H. B. ROBINSON STEAM ELECTRIC PLANT, UNIT NO. 2
DOCKET NO. 50-261/LICENSE NO. DPR-23

TRANSMITTAL OF EMERGENCY PLAN AND PROCEDURE REVISIONS

PLP-007
Robinson Emergency Plan
Revision 46

FIGURE 5.3.5-5
INTERFACES FOR GENERAL EMERGENCY PRIOR TO EOF ACTIVATION

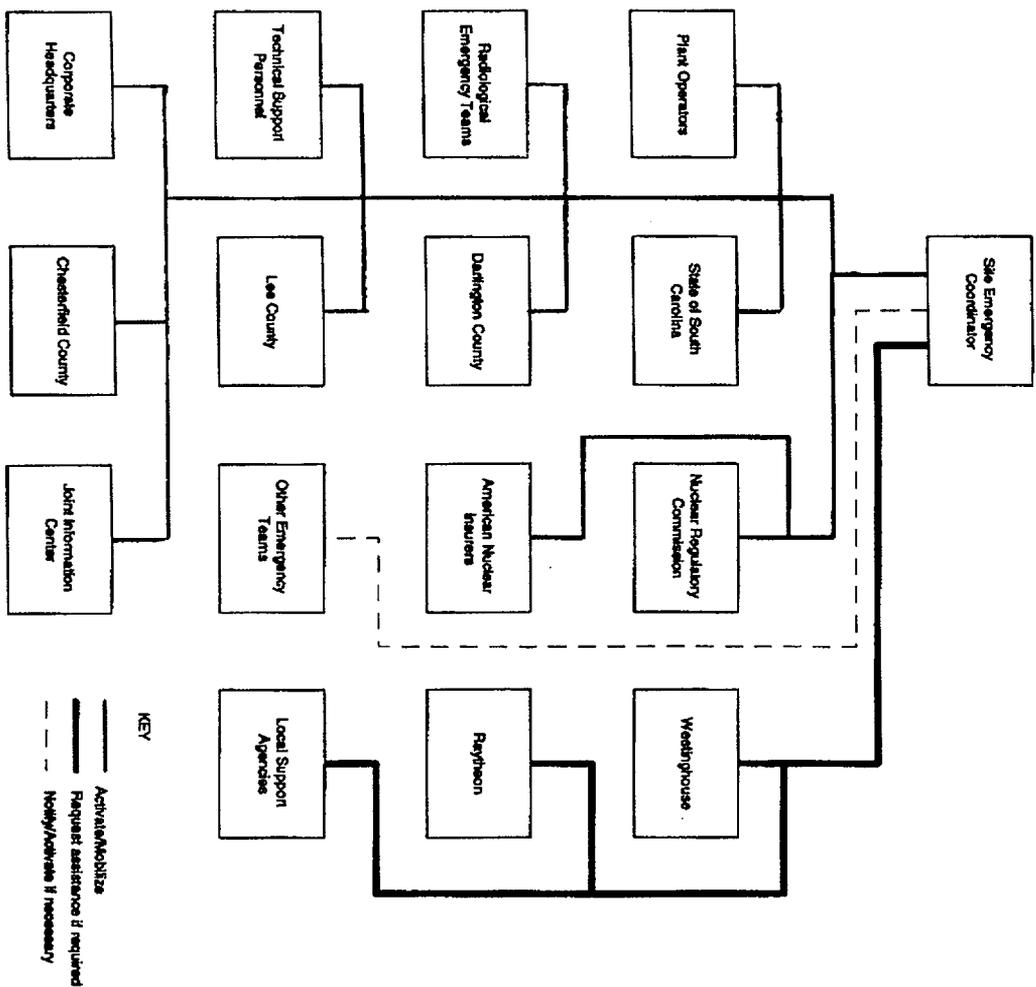
5.5.8	The fire detection description was not technically accurate.	Corrected terminology for technical accuracy.
Figure 5.3.5-5	Title references the FEOC.	Deleted FEOC reference.
Figure 5.3.5-6	Title references the FEOC.	Deleted FEOC reference.
Table 5.3.2.1	Rescue and first responders listed RC technicians and Security personnel	Chemistry Technicians were added as personnel available for this position.
Table 5.5.0-1	Provides functional objectives for the FEOC.	Deleted FEOC functional objectives.
Attach 6.4	Copy 147 of the Robinson Emergency Plan was issued to INPO.	At the request of INPO a copy of the Robinson Emergency Plan is longer sent to INPO. Revised address for the SCEPD.

FIGURE 5.3.5-6
INTERFACES FOR GENERAL EMERGENCY AFTER EMERGENCY OPERATIONS
FACILITY ACTIVATION

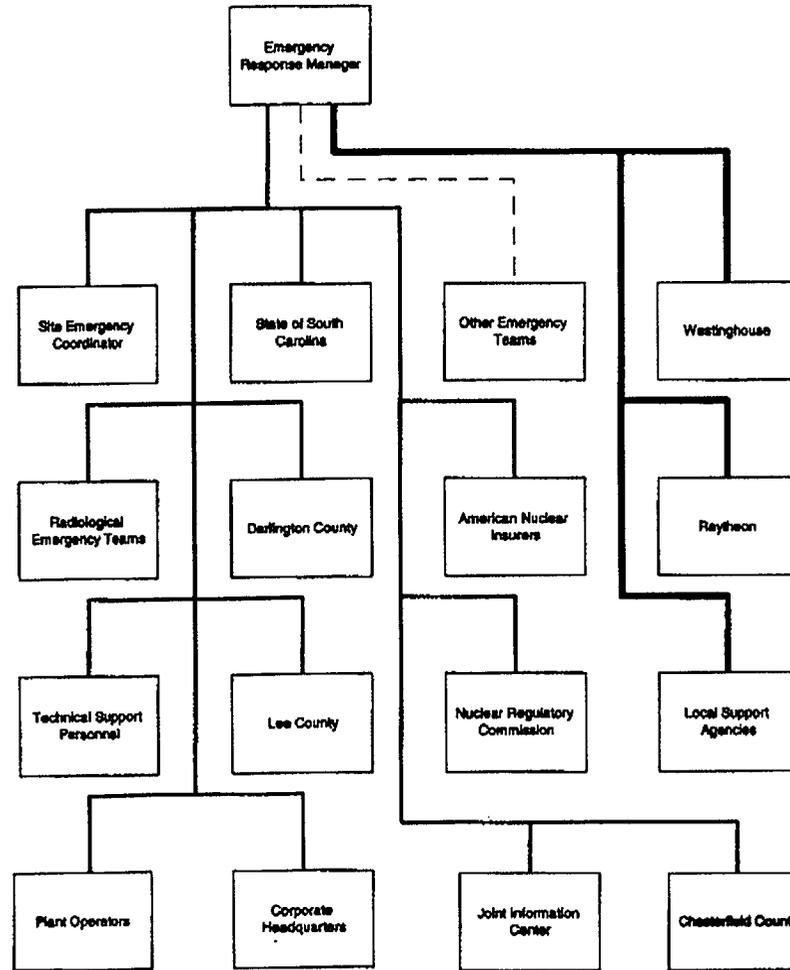
5.3.4.5b	Step provides a FEMA representative at the FEOC.	Deleted the reference to the FEOC. the SCEPD no longer activates/supports the FEOC. .
5.4.1.5	Paragraph references Figure 5.3.5-6 with FEOC in title.	Deleted FEOC reference.
